F-35 Joint Strike Fighter Concurrency Quick Look Review

Quick Look Review of F-35 Joint Strike Fighter Concurrency November 2011

Executive Summary

Figure 8: Arresting Hook Geometry

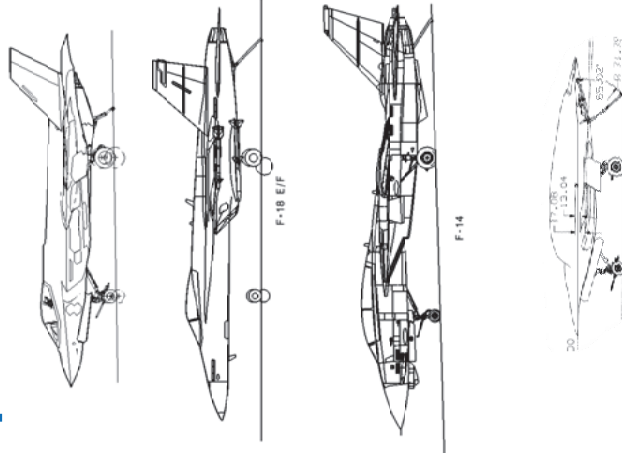
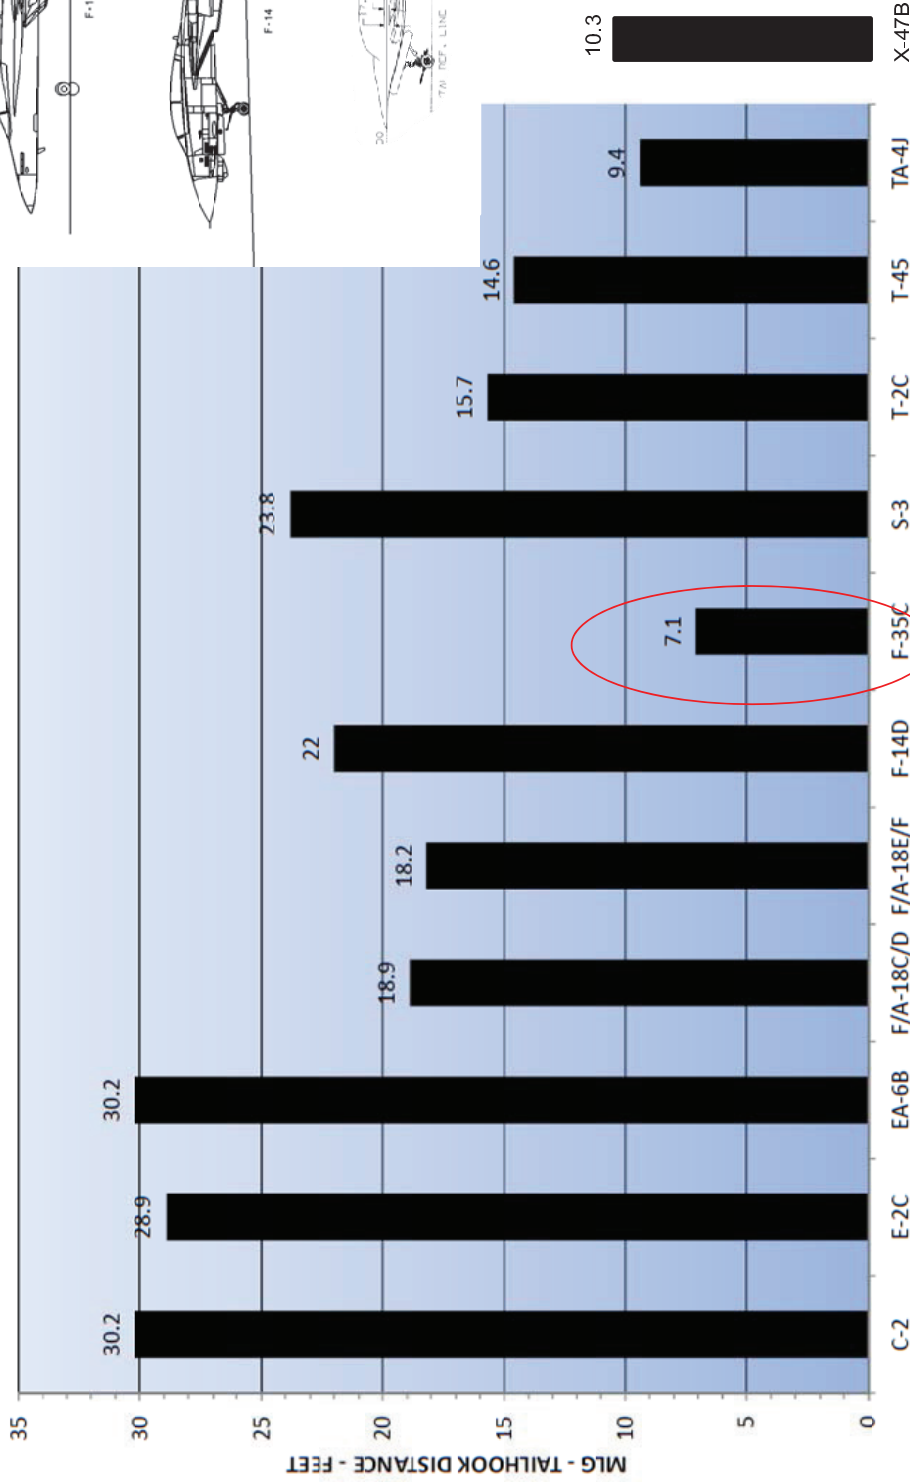
Arresting Hook System (CV variant): There are significant issues with respect to how the CV variant's AHS interoperates with aircraft carrier based MK-7 arresting gear. Roll-in arrestment testing at NAWC-AD, Lakehurst, resulted in no successful MK-7 engagements (0 successes in 8 attempts). Root cause analysis identified three key AHS design issues: (1) the aircraft geometry has a relatively short distance between the aircraft's main landing gear tires and tailhook point (when lowered), (2) tailhook point design was overemphasized for cable shredding features versus ability to scoop low positioned cables, and (3) tailhook hold-down damper performance is ineffective to support damping of small bounces relative to runway / deck surface profiles.

As shown in Appendix Figure 8, page A-9, the F-35C's main landing gear to tailhook point distance is 7.1 feet. Accordingly, when the aircraft's main landing gear rolls over the arresting cable, the responsive dynamics are such that the cable lies nearly flat on the deck. Comparing similar geometries with other, currently operating carrier based aircraft which range from 30.2 feet (C-2) to 14.6 feet (T-45), the F-35C is an outlier. The current F-35C tailhook point design (Appendix Figure 9, page A-10) was based on the F/A-18E/F design which has a blunt face to better provide cable shredding protection versus scooping. However, the F/A-18E/F's geometry places the distance of its main landing gear to tailhook point at 18.2 feet; a much longer distance than the F-35C. Since there is more distance in the geometry, the trampled cable has enough time to respond and flex back toward its original setting position by the time the tailhook point intercepts for arrestment. The hold-down damper contributes to overall aircraft arresting gear poor performance by allowing the tailhook to bounce excessively.

Hook Point Geometry Improvement

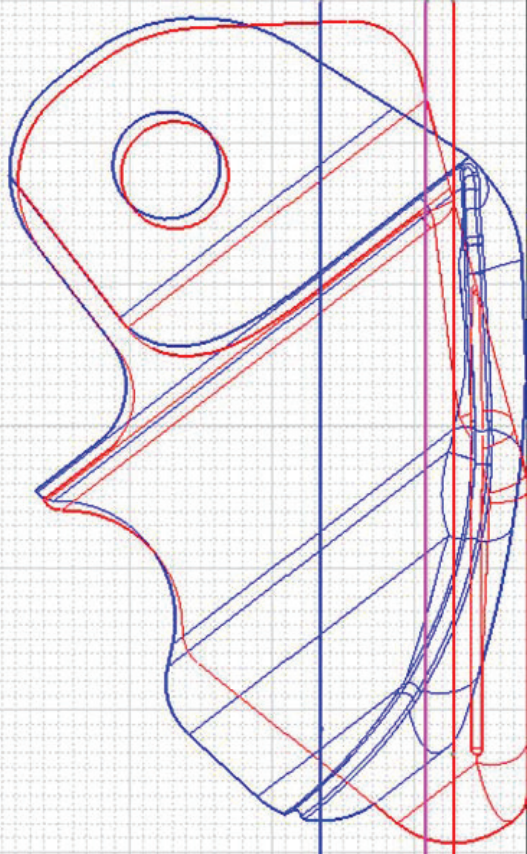
To address these issues, the program is designing modifications to the tailhook point and hold down damper components. The proposed hook point redesign in Appendix Figure 10, page A-11, both reduces the blunt face geometry with a more pointed front end and lowers its apex point by 0.5 inches (68%) such that it is now below the arresting gear cable centerline to better enable scooping performance. The proposed hold down damper redesign will consist of modifications to the AHS actuator damper such that a lesser number of orifices will temper tailhook bounce dynamics (Appendix Figure 11, page A-12). The AHS redesigned components will undergo Monte Carlo probability of engagement analysis as a lead-in effort for design review which is scheduled in December 2011. Following successful design review, the plan is to manufacture the redesigned components and then conduct rolling engagements at NAWC-AD, Lakehurst in April 2012.

Figure 12: F-35A Buffet at 10000 ft MSL

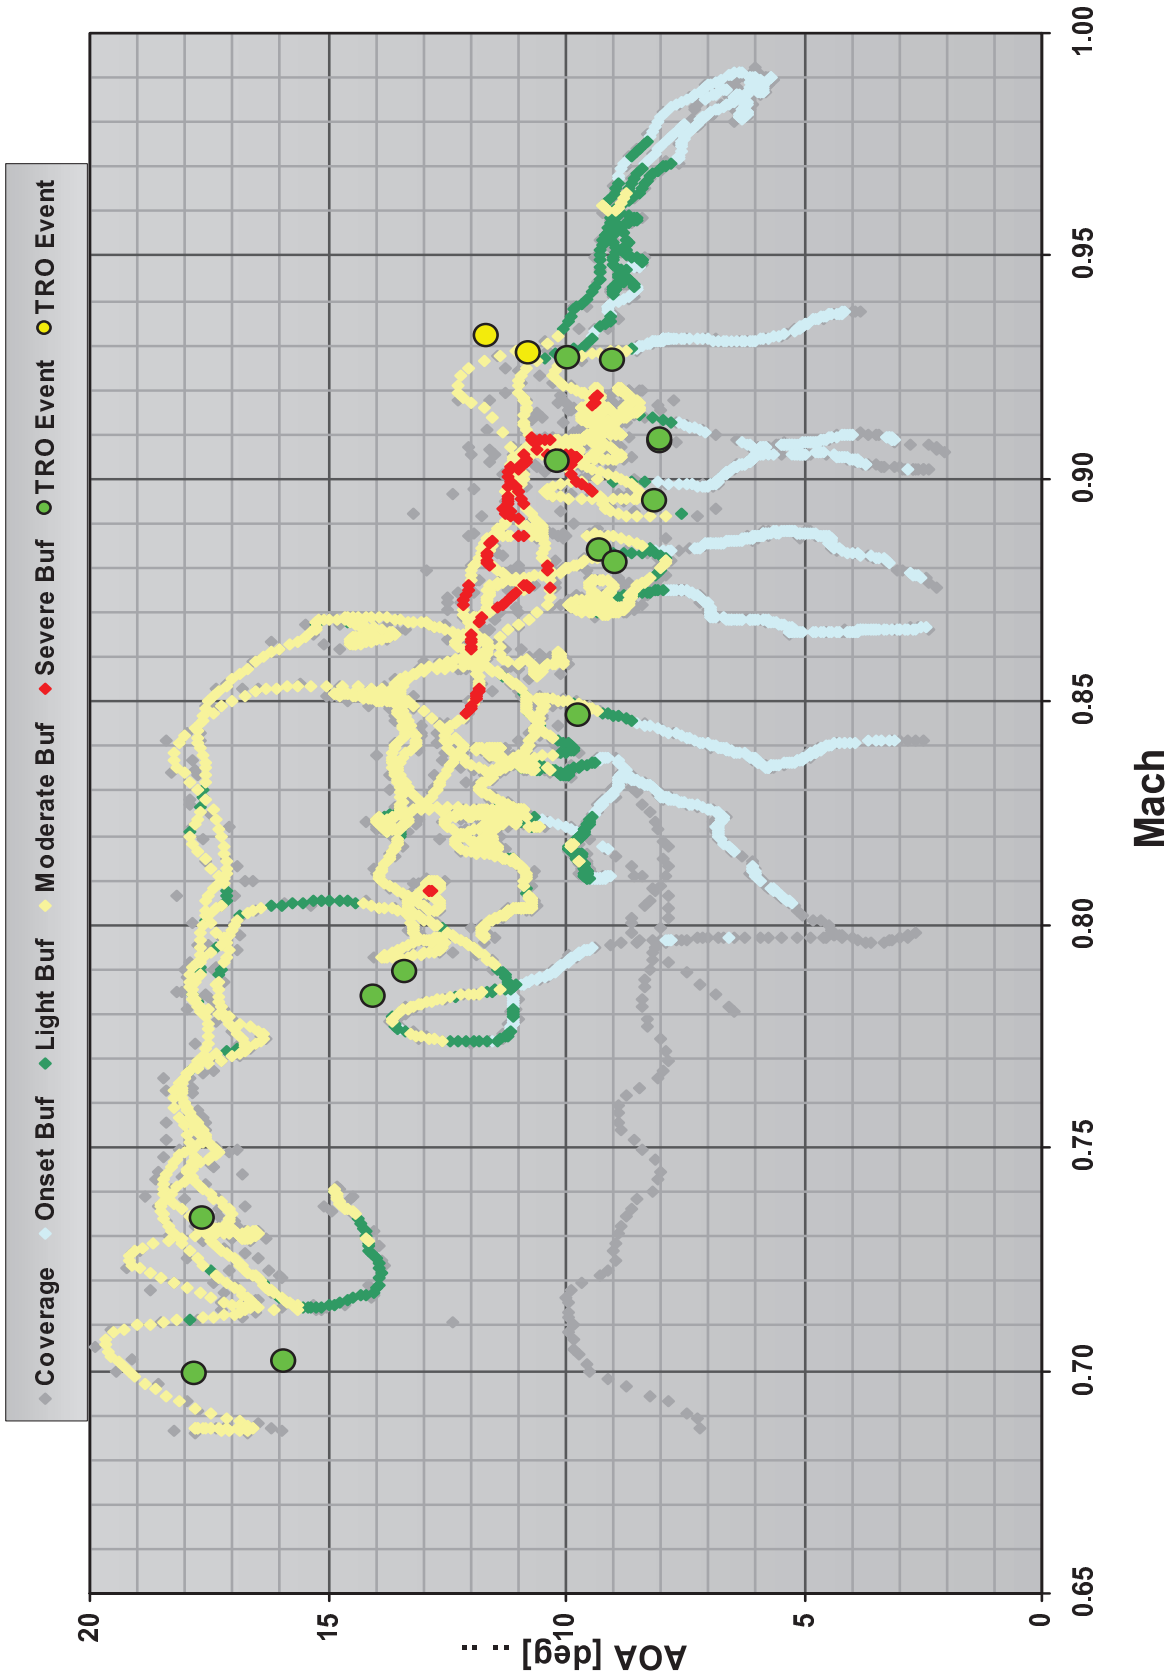
Buffet also affects the ride quality of the aircraft, and the ability of the pilot to manage workload, perform fine tracking operations, such as required for HOBS missile targeting and gun-tracking tasks, and manipulate controls that require fine motor skills. Although the buffet severity experienced so far has been described as similar to that seen in previous tactical aircraft, the buffet does occur in an important and large part of the flight envelope. Appendix Figure 12, page A-13, shows an example of buffet flight test data at 10000 ft MSL.

Figure 13: Life Limited Parts

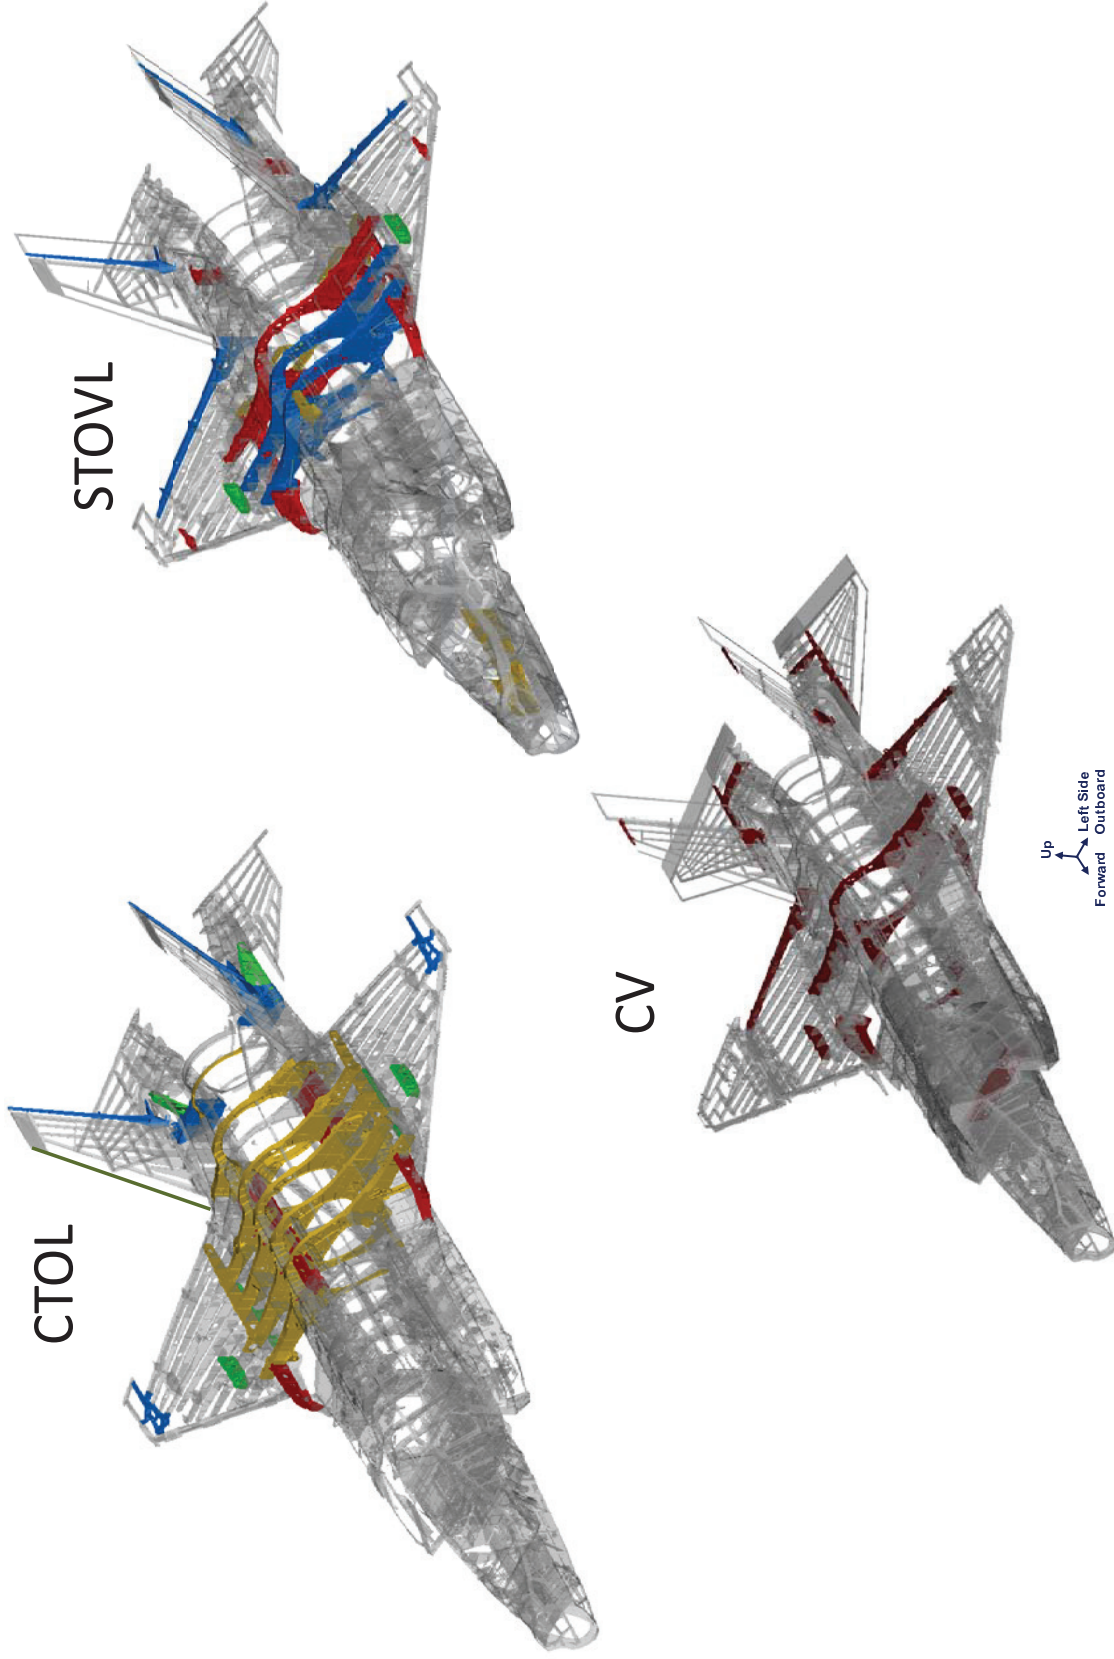
Fatigue Life: Fatigue tests are a primary element used to certify airframe structures for their required service life, and in the process of doing so, experience test failures that identify individual airframe components that fall short of this requirement. The consequence is that aircraft that have been delivered, or will be delivered before changes can be incorporated in production, will not meet requirements for airframe life. The options may include accepting the shorter lives of affected aircraft, inspecting aircraft more often, or retrofitting the aircraft with structural modifications. Modifications can be expensive for individual aircraft, and obviously become cumulatively more expensive as the number of affected aircraft

increases. Appendix Figure 13, page A-14, shows examples of life limited structural parts and their relative difficulty to access and modify.

Figure 26: STOVL Hover CG History

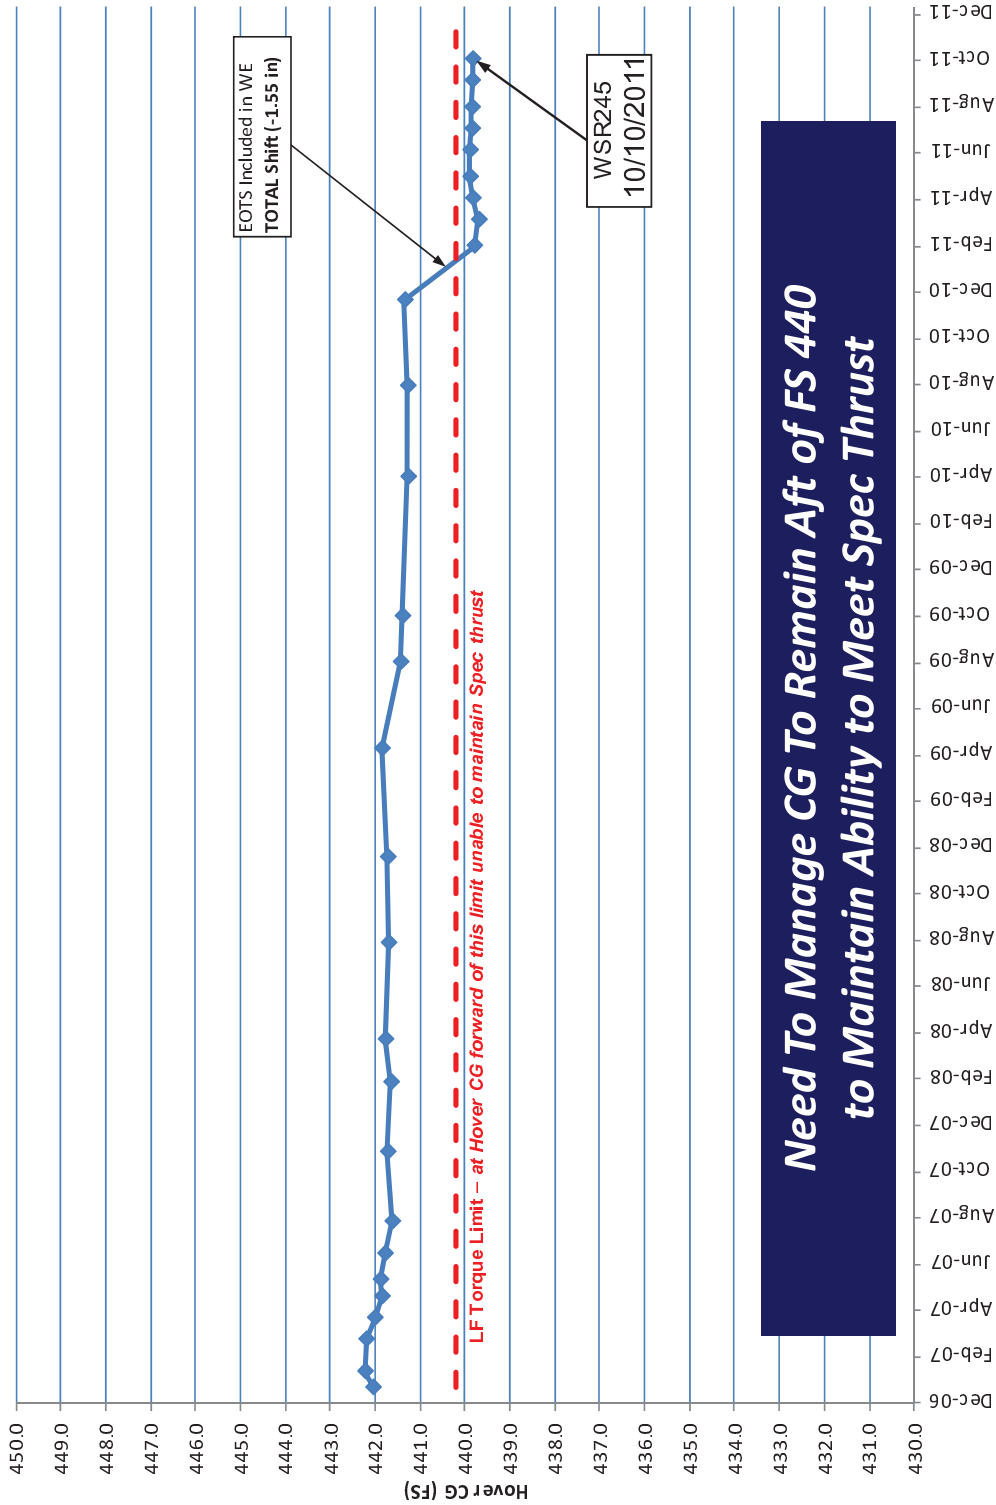
The STOVL weight challenge is further complicated by the need to maintain a center of gravity (C.G.) aft of Flight Station (SF) 440, which is required to meet specification required thrust (Appendix Figure 26, page A-27). The impact of the current C.G. further limits weight reductions aft of FS 440

Figure 29: Panoramic Cockpit Display Thermal Issue

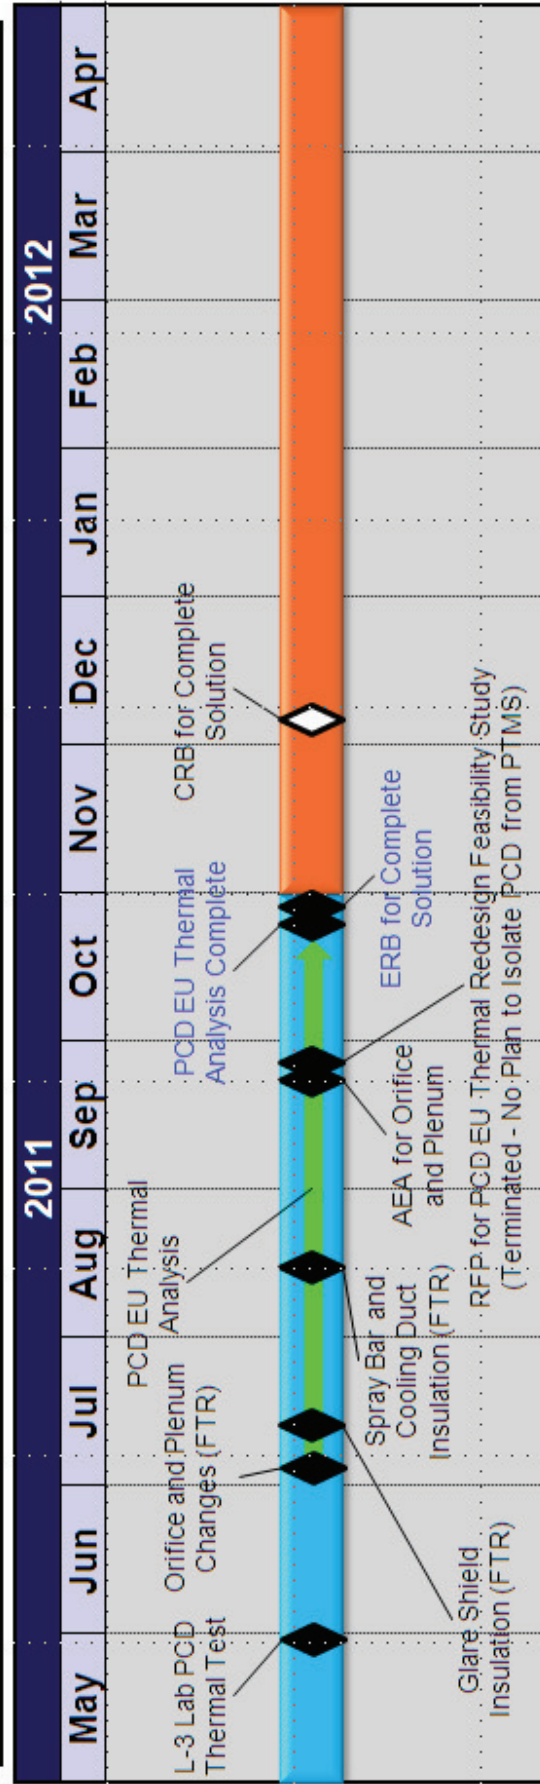
The thermal environment (cooling air and ambient temp) provided to the panoramic cockpit display (PCD) does not meet specifications and is more severe than designed / expected, causing the PCD electronics unit (EU) to overheat (Appendix Figure 29, page A-30). While previous changes have resulted in some improvement, the issues have not been resolved. Also, aircraft supply / exhaust plenums are leaking on some aircraft leading to improper cooling flow at altitude.

- Thermal Analysis Complete (Cooling System Not Providing Expected Air Temp and Flow)
- Cooling Air Orifice and Plenum Changes Evaluated in Flight Test
- Resulted in Improvement, but is Not Resolved
- Proposed Complete Solution Briefed at ERB
- Orifice Change, New Plenum, Cooling Duct Insulation, PCDEU Spray Bar, PTMS Software Change to Increase Ground Cooling Cart Flow
